UNITED STATES PATENT AND TRADEMARK OFFICE

Supplemental
Office Action Summary

Application No.	Applicant(s)	
10/797,571	MOTO, AKIHIRO	
Examiner	Art Unit	
Delma R. Flores Ruiz	2828

FIG. 11 (PRIOR ART)

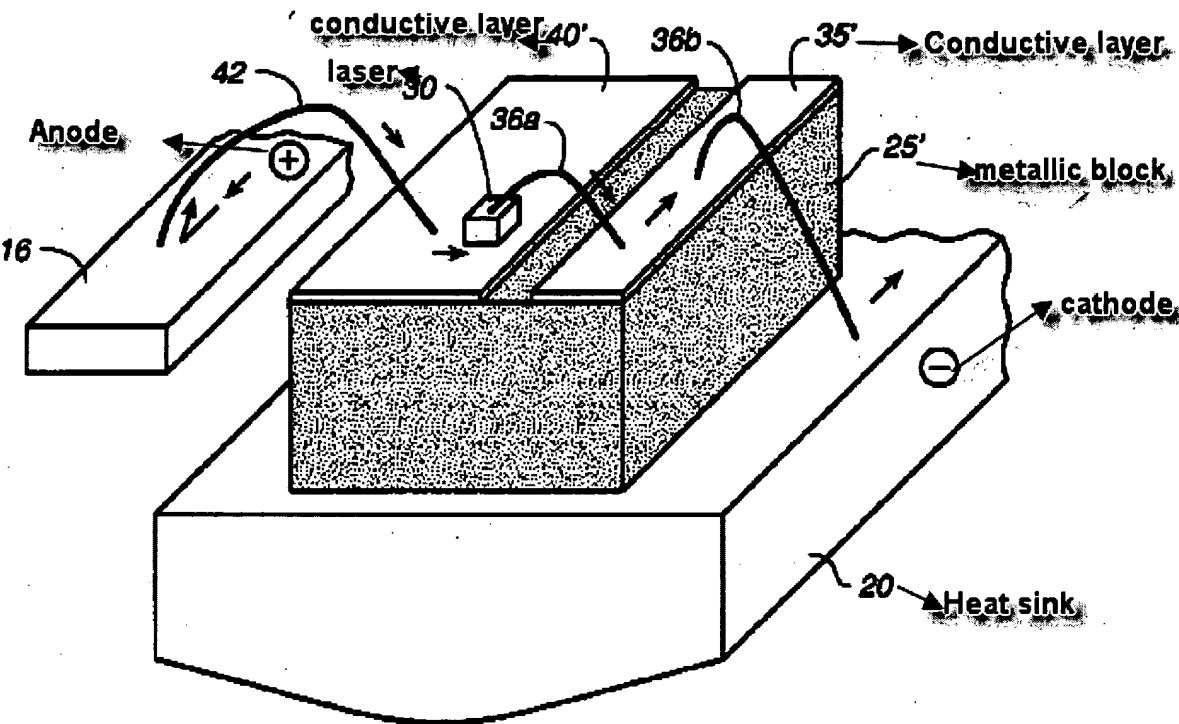
Regarding claim 1, Uchida discloses in Figure 11 and 12 a light-transmitting module, comprising: a stack of a metallic block (see Fig. 11, Character 25', Column 2, Lines 20 – 21), an insulating heat sink (21see Fig. 11, Character 20) mounted on said

metallic block and an electrically conductive layer (see Fig. 11, Characters 35' and 40') formed on said insulating heat sink, said stack forming a parallel-plate capacitor; and a laser diode (see Fig. 11, Character 30) having an anode and a cathode, said laser diode being mounted on said conductive layer such that said anode faces and is in contact with said conductive layer (Column 1, Lines 31 – 34, Column 2, Lines 11 – 41 and Column 3, Lines 1 – 10) .

Regarding claim 6, Uchida discloses in Figure 11 and 12 a light-transmitting module, comprising: a stack of an electrically conductive heat sink (see Fig. 11, Character 25', Column 2, Lines 20 – 21), an insulating layer provided on said heat sink (21see Fig. 11, Character 20) and an electrically conductive layer (see Fig. 11, Characters 35' and 40'), said stack forming a parallel-plate capacitor; and a laser diode (see Fig. 11, Character 30) mounted having an anode and a cathode, said laser diode being mounted on said conductive layer such that said anode faces and is in contact with said conductive layer (Column 1, Lines 31 – 34, Column 2, Lines 11 – 41 and Column 3, Lines 1 – 10)
